Agenda  
for  
**151<sup>st</sup> PCC Meeting**

### **AGENDA FOR 151<sup>ST</sup> PROTECTION COORDINATION SUB-COMMITTEE MEETING TO BE HELD ON 18<sup>TH</sup> SEP 2025 AT 11:00 HRS THROUGH MS TEAMS**

**पूर्वी क्षेत्र के 400 केवी दिक्चू में ग्रिड घटना पर विस्तृत रिपोर्ट / Detailed Report of grid event at 400 kV  
 Dikchu S/s of Eastern Region  
 (To be submitted by RLDC/NLDC during Grid Disturbances/Grid Incidents/Near Miss Event as  
 per IEGC section 37.2 (f))  
 (आई ई जी सी 37.2 (एफ) के अनुपालन में)**

**Figure 2: SLD of 400kV Dikchu S/s**

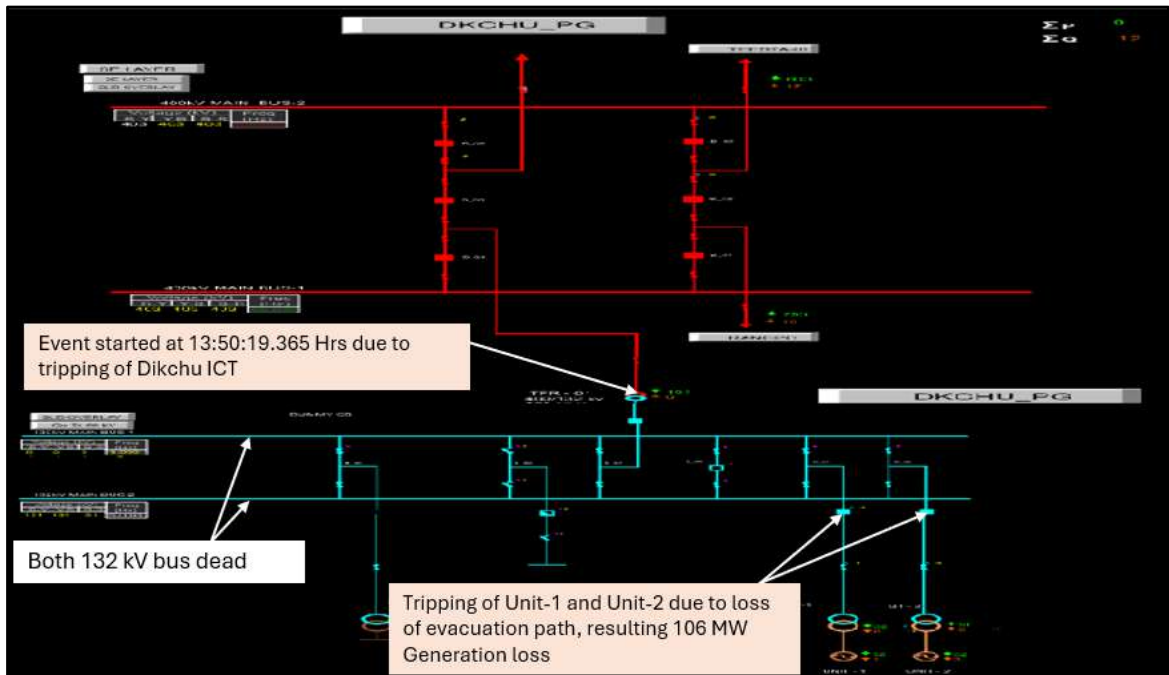
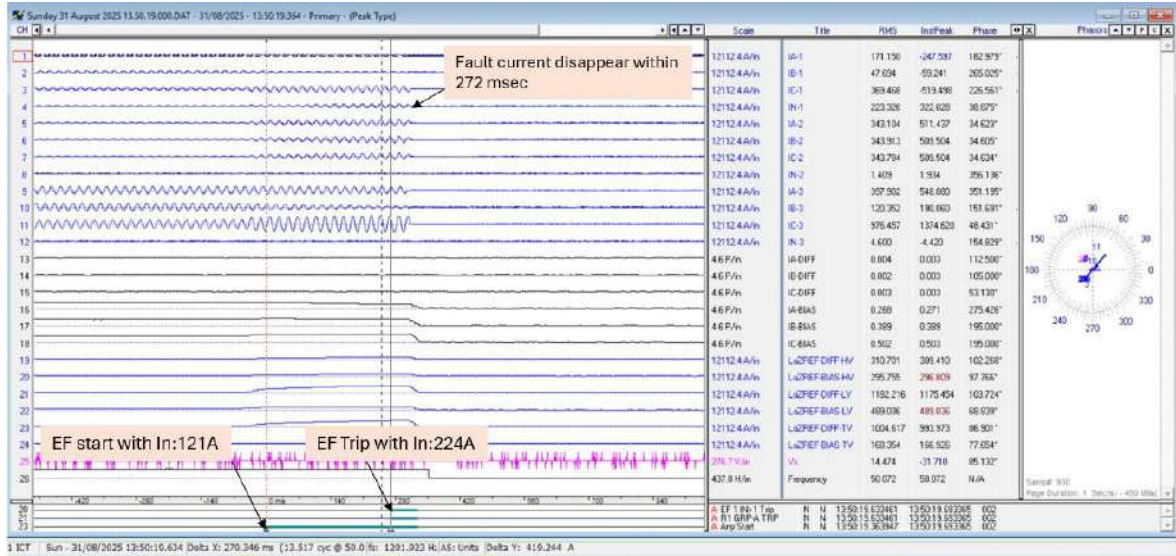
- O/C Earth fault setting kept as non-directional, which was not as per ERPC protection philosophy and decided in 148<sup>th</sup> PCC meeting.

- b. ERLDC mentioned discrepancies, observed in HV side Backup OC EF setting for 400/132kV ICT at Dikchu HEP and the same is listed below:
    - Back-up OC Earth Fault setting configured as non-directional instead of directional towards ICT.

- High set pickup for Back-up OC EF setting is not in line with ERPC protection philosophy.
    - Different B/U OC EF settings were implemented in P643 87T and P645 OA relay.

- O/C Earth fault setting may be reviewed, and it is to be revised as per Protection philosophy of ERPC.
- MOM of meeting held on 03/09/2025 is attached in Annexure 1.

- c. Dikchu HEP clarified that the directional feature was not visible in Relay P643 87T during implementation of the recommended setting. However, presently they made it directional after the event.

- d. ERPC recommended that backup protection setting may be implemented in one relay. However, if enabled in both relays identical setting should be implemented for uniformity.

**DR of 400kV Lapanga-OPGC #1 at OPGC end 3**

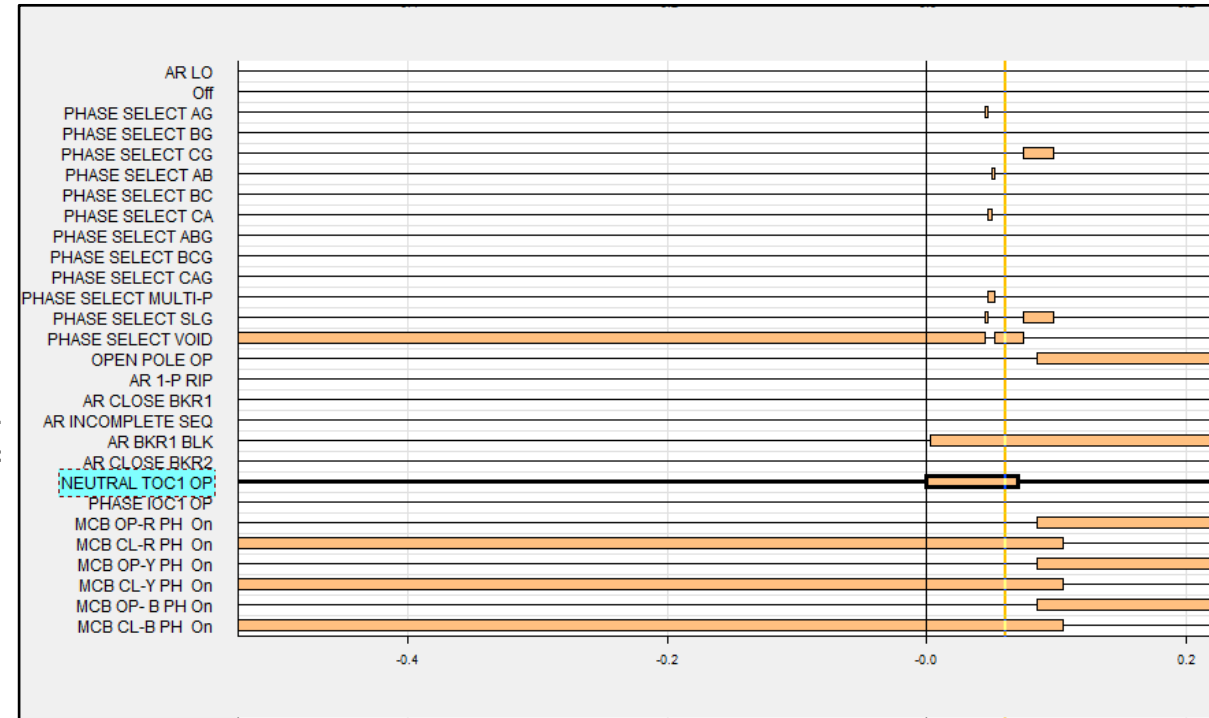
- ❑ 400kV OPGC-Lapanga D/C tripped from OPGC end on over current earth fault and DT send to Lapanga end.
- ❑ As per ERPC protection philosophy O/C earth fault should be in directional nature.
- ❑ As per DR of 400kV Lapanga Sterlite D/C, Neutral TOC operated which is non-directional in nature and pickup current is 200 A(10 % of base current).
- ❑ During charging of 400kV Lapanga-OPGC D/C, line could not be synchronized immediately at OPGC end due to conservative angular separation setting in auto synchro-check relay which was 10 degree. Angular separation setting in auto synchro-check relay increased to 20 degree.

**DR of 400kV Lapanga-Sterlite #2 at Sterlite end**

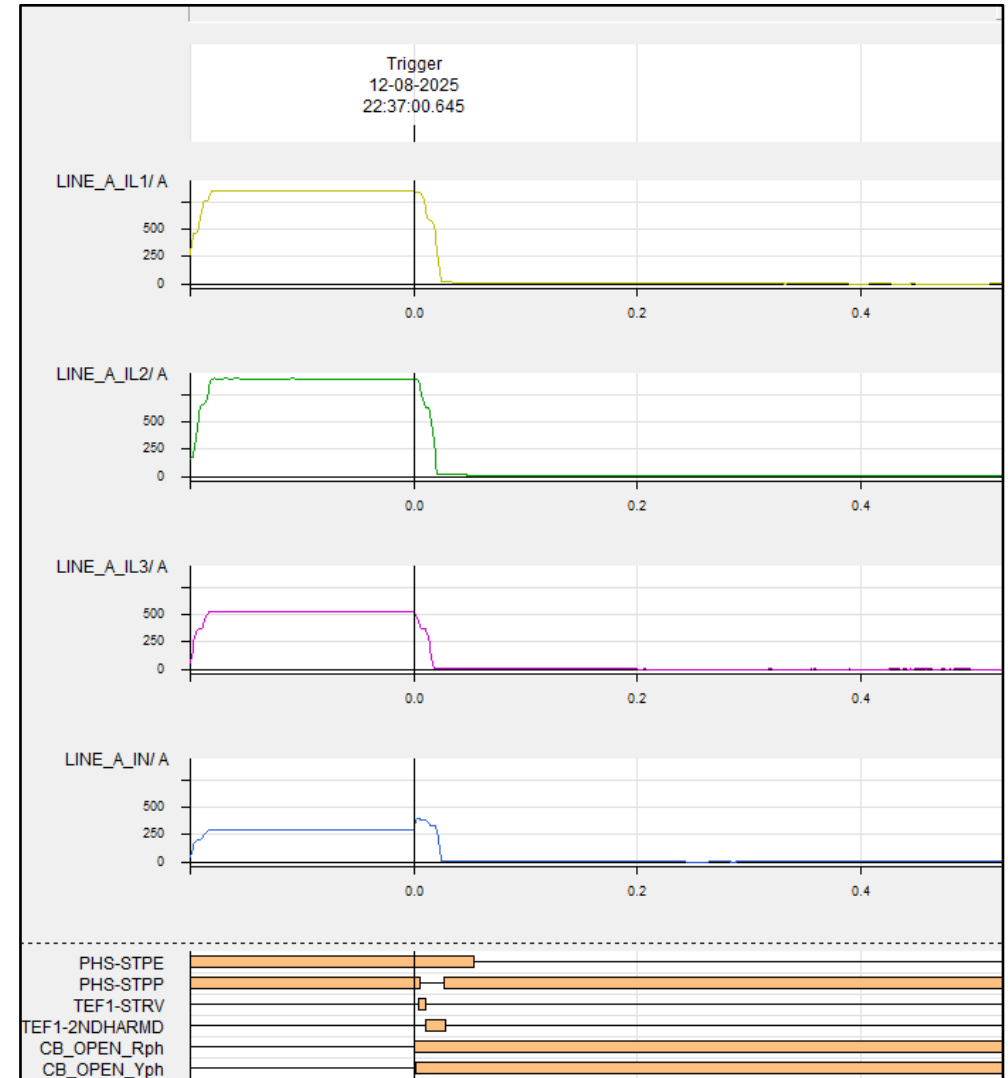
- ❑ 400kV Sterlite-Lapanga #2 tripped from Sterlite end on over current earth fault protection.
- ❑ DEF protection didn't operate for 400kV Lapanga-Sterlite #1 at Sterlite end.(E/F setting kept non-directional at Sterlite end with pickup current 200 A).
- ❑ As per ERPC protection philosophy O/C earth fault should be in directional nature but at Sterlite end non-directional O/C earth fault setting is enabled with pickup current is 200 A(10 % of base current).
